**Subject: Chiquita Canyon LLC's Response to the LEA's Comment Letter on the Final Construction Report 2024-2025 Temperature Monitoring Probe Installation at the Chiquita Canyon Landfill**

The LEA, in collaboration with the California Department of Resources, Recycling and Recovery (CalRecycle), requested a revised Final Report to include the recently installed thermocouples for TP-22, TP-23 and TP-33, and to address the comments below.

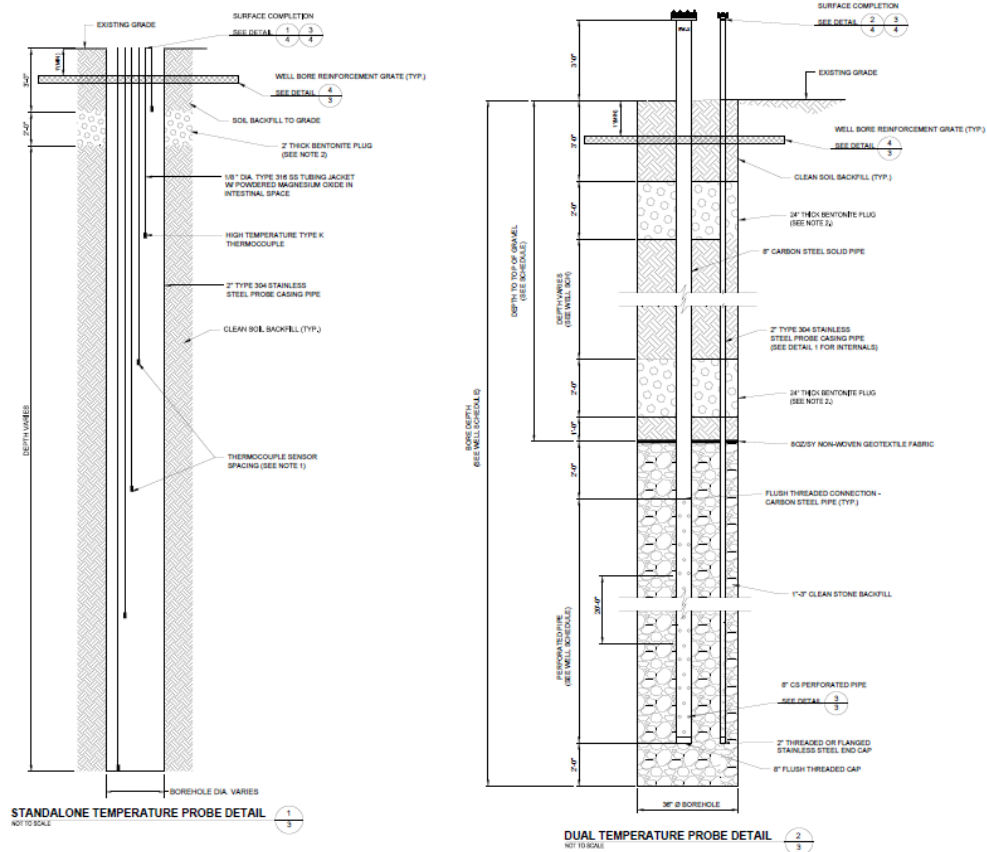
*4. Provide manufacturer information or model number of the TMPs used.*

The installed thermocouples are Cleveland Electric thermocouples model MGO-K-3-4-U.

SHEET TITLE: EXISTING TEMPERATURE PROBE MAP  
 PROJECT TITLE: CHIQUITA CANYON LANDFILL  
 CASTAIC, CALIFORNIA

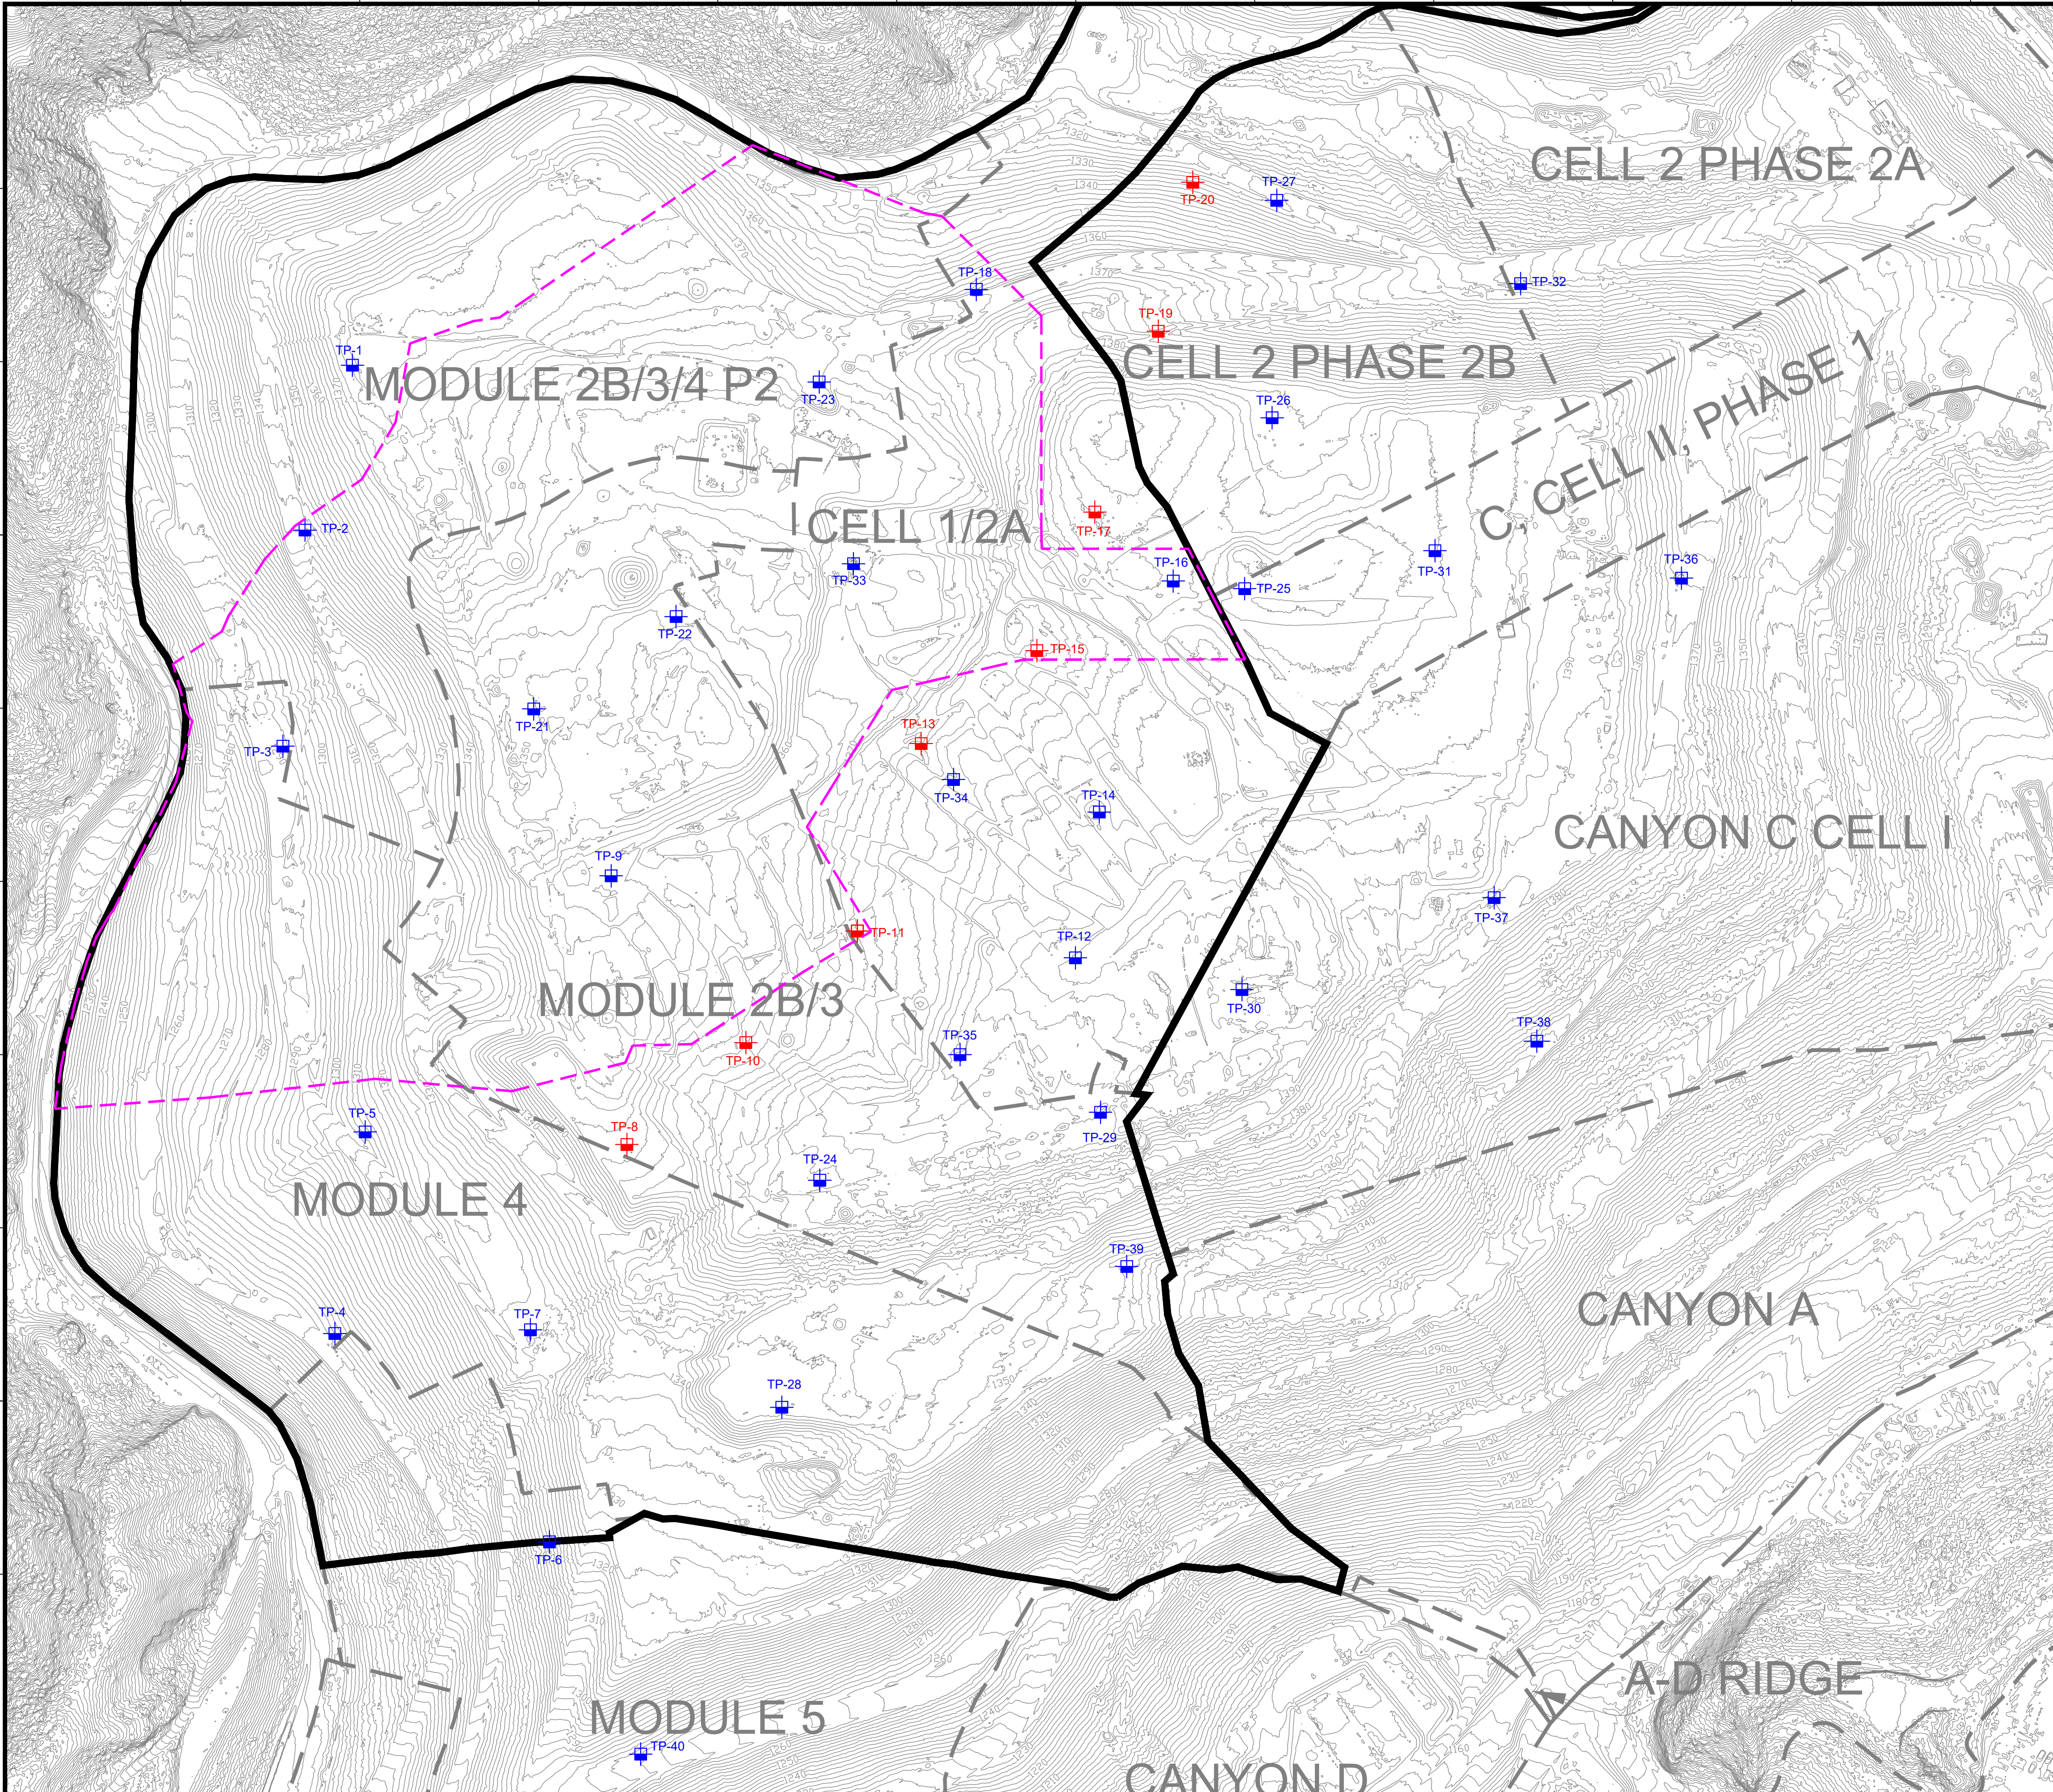
In April of 2025, TMP-35 was installed to the correct depth. In May of 2025, the eight TMPs were shown to be at the correct installation depth with no explanation in the Excel spreadsheet. Provide as-builts for all TMPs, showing the actual depths. Provide evidence that this was either corrected or updated in the spreadsheet.

At the request of the LEA, the Excel spreadsheet submitted as part of the weekly TMP updates is made up of raw data and thus does not include explanatory language. As-built map for all TMPs are attached as stipulated in the LEA's letter dated May 8, 2024, Items 2 and 3, and in the LEA's June 6, 2024, Compliance Order. The actual depths are included in the weekly raw data spreadsheets and submitted to the LEA as part of the TMP updates.
